<b>APPLICATION FOR PERMIT TO DRILL</b>		5. MINERAL LEASE NO: ML-47085	6. SURFACE: State
1A. TYPE OF WORK: DRILL <input checked="" type="checkbox"/> REENTER <input type="checkbox"/> DEEPEN <input type="checkbox"/>		7. IF INDIAN, ALLOTTEE OR TRIBE NAME:

2. NAME OF OPERATOR: The Houston Exploration Company		9. WELL NAME and NUMBER: Buck Canyon 15-16-12-21	
3. ADDRESS OF OPERATOR: 1100 Louisiana, Suite 200 CITY Houston STATE TX ZIP 77002		PHONE NUMBER: (713) 830-6800	10. FIELD AND POOL, OR WILDCAT: Buck Canyon

**WORKSHEET  
APPLICATION FOR PERMIT TO DRILL**

**DIVISION OF OIL, GAS AND MINING  
APPLICATION FOR PERMIT TO DRILL  
STATEMENT OF BASIS**

**Evaluation Ranking Criteria and Ranking Score  
For Reserve and Onsite Pit Liner Requirements**

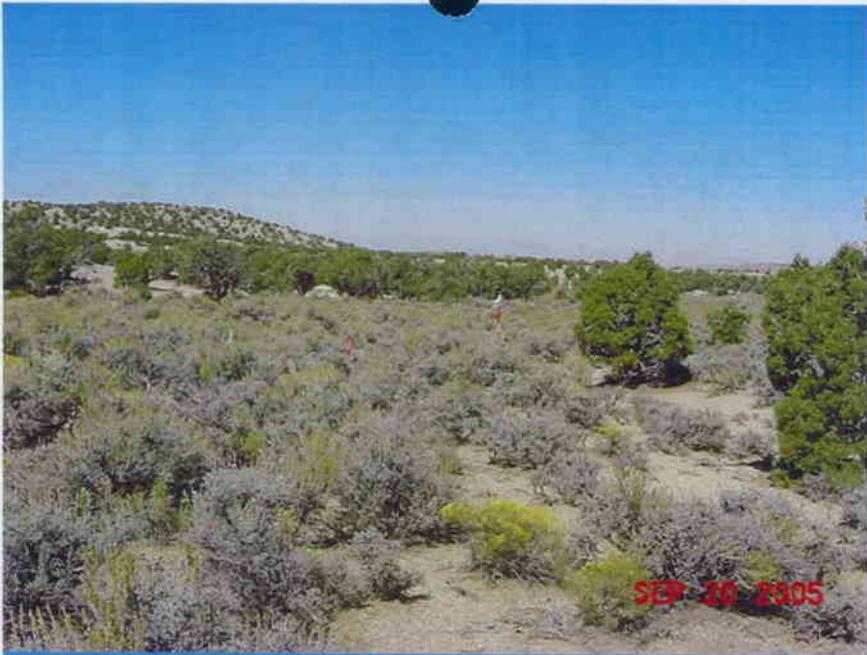
LINER REQUIREMENTS (Site Ranking Form attached): A liner and felt sub-liner will be required for reserve pit. Site ranking score is 30.

<u>Site-Specific Factors</u>	<u>Ranking</u>	<u>Site Ranking</u>
Distance to Groundwater (feet)		
>200	0	
100 to 200	5	
75 to 100	10	
25 to 75	15	
<25 or recharge area	20	<u>5</u>
Distance to Surf. Water (feet)		
>1000	0	
300 to 1000	2	
200 to 300	10	
100 to 200	15	
< 100	20	<u>0</u>
Distance to Nearest Municipal Well (feet)		
>5280	0	
1320 to 5280	5	
500 to 1320	10	
<500	20	<u>0</u>
Distance to Other Wells (feet)		
>1320	0	
300 to 1320	10	
<300	20	<u>0</u>
Native Soil Type		
Low permeability	0	
Mod. permeability	10	
High permeability	20	<u>20</u>
Fluid Type		
Air/mist	0	
Fresh Water	5	
TDS >5000 and <10000	10	
TDS >10000 or Oil Base Mud Fluid	15	
containing significant levels of hazardous constituents	20	<u>5</u>
Drill Cuttings		
Normal Rock	0	
Salt or detrimental	10	<u>0</u>
Annual Precipitation (inches)		
<10	0	
10 to 20	5	
>20	10	<u>0</u>
Affected Populations		
<10	0	
10 to 30	6	
30 to 50	8	
>50	10	<u>0</u>
Presence of Nearby Utility Conduits

Not Present	0	
Unknown	10	
Present	15	<u>0</u>
<b>Final Score</b>	<u>30</u>	<b>(Level I Sensitivity)</b>

1. A synthetic liner with a minimum thickness of 12 mils with a felt subliner shall be properly installed and maintained in the reserve pit.

10-05 Houston Buck Cyn 15-16-12-21  
Casing Schematic

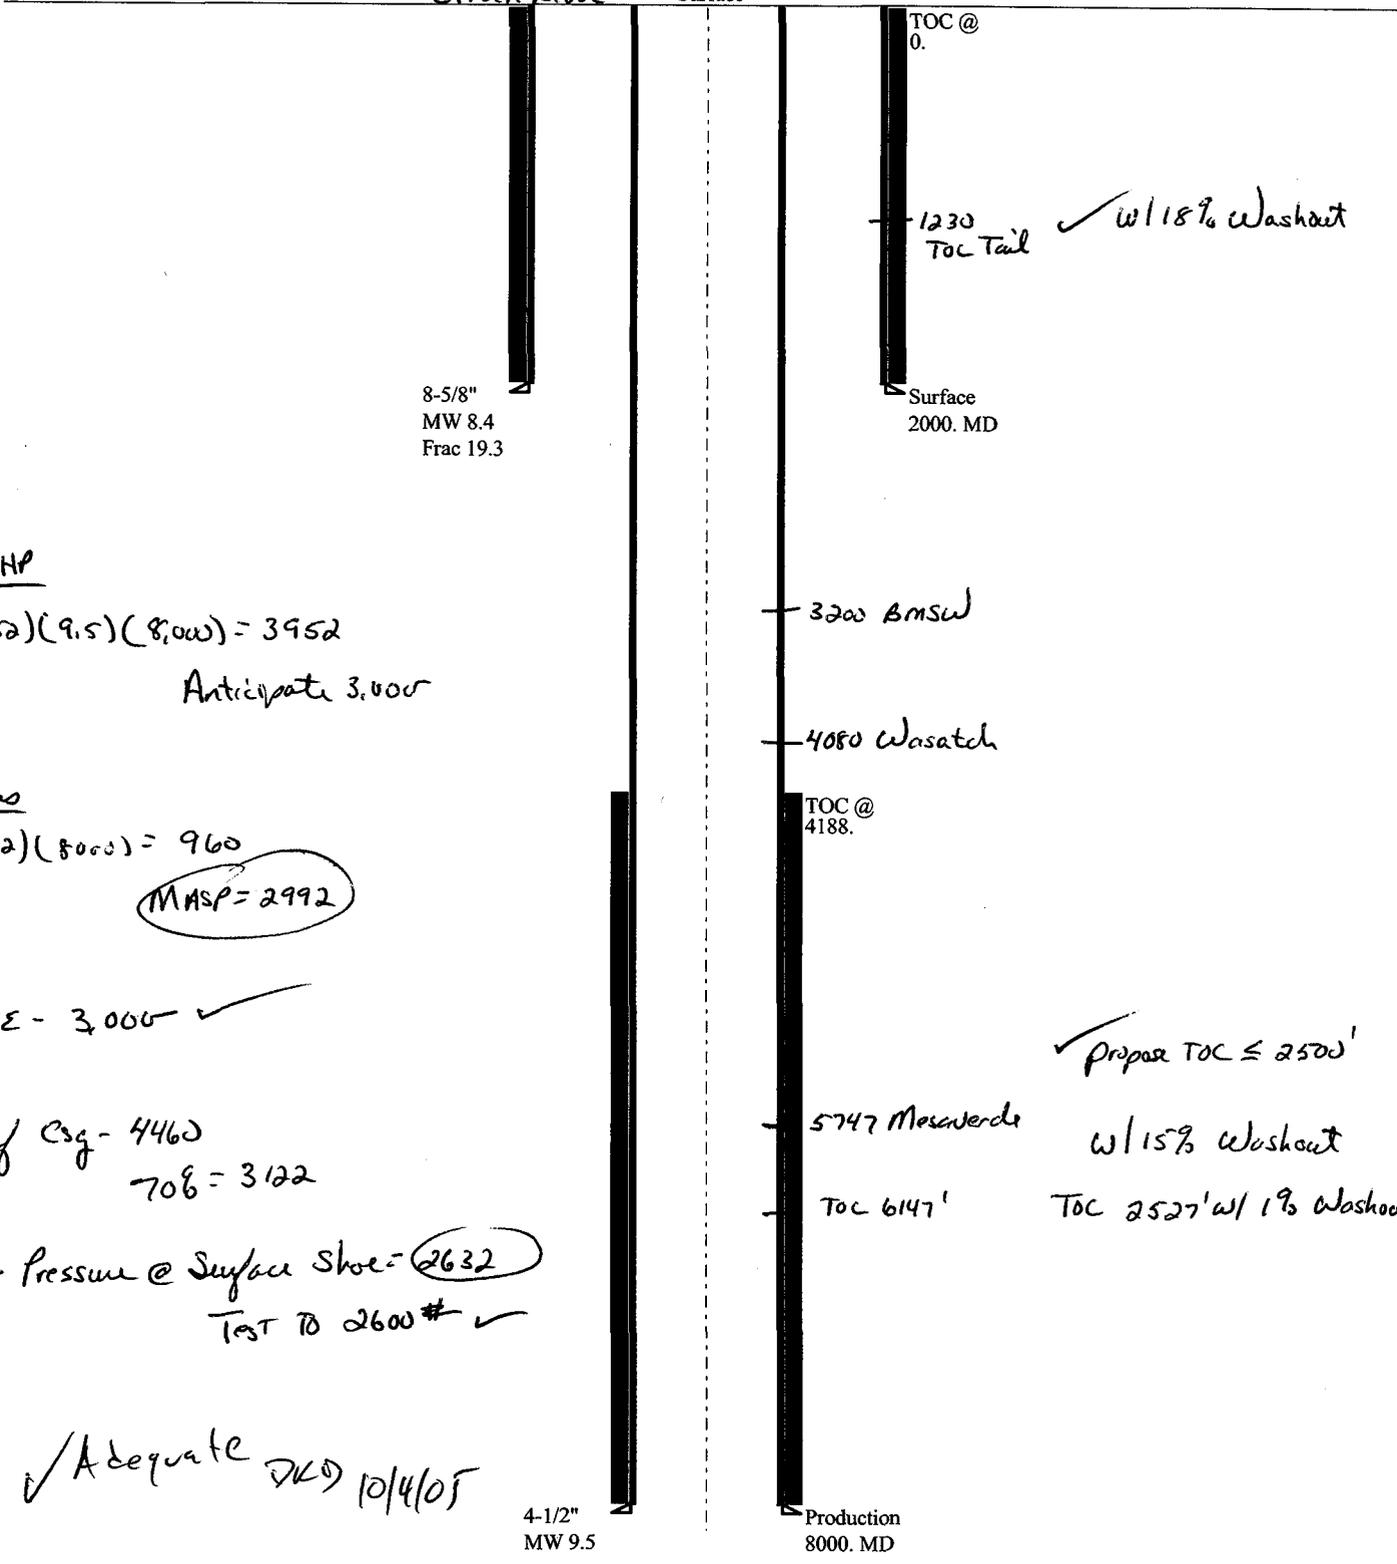
8-5/8"  
MW 8.4  
Frac 19.3

TOC @  
0.

1230  
TOC Tail

✓ w/ 18% Washout

Surface  
2000. MD

3200 BMSW

TOC @  
4188.

TOC 6147'

✓ Prepare TOC ≤ 2500'

w/ 15% Washout

TOC 2527' w/ 1% Washout

4-1/2"  
MW 9.5

Production  
8000. MD

BHP

$$(0.052)(9.5)(8,000) = 3952$$

Anticipate 3,000

$$(12)(8000) = 960$$

MASP = 2992

BOPE - 3,000 ✓

Surf Csg - 4460

Max Pressure @ Surface Shoe = 2632

Test to 2600# ✓

✓ Adequate 2600 10/4/05

7. Cement volume for the 4 1/2" production string shall be determined from actual hole diameter in order to place cement from the pipe setting depth back to  $\pm 2500'$  MD as indicated in the submitted drilling plan.
